9.4.2.199 TWT element

Replace Figure 9-686 with the following figure:

Figure 9-688—Request Type field format in [Individual TWT Parameter Set field](#)

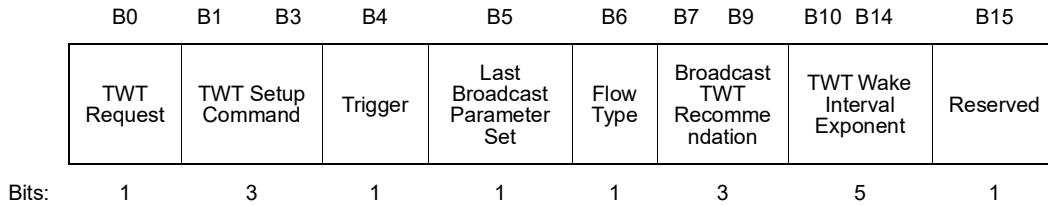
Change the following block of text (i.e., now 13th through 22nd paragraphs) (including changing Figure 9-688 and Table 9-297 and inserting Figure 9-688a and Table 9-297a) in 9.4.2.199 as shown:

The format of the Request Type field [of the Individual TWT Parameter Set field](#) is shown in Figure 9-688 [and of a Broadcast TWT Parameter Set field is shown in Figure 9-688a.](#)
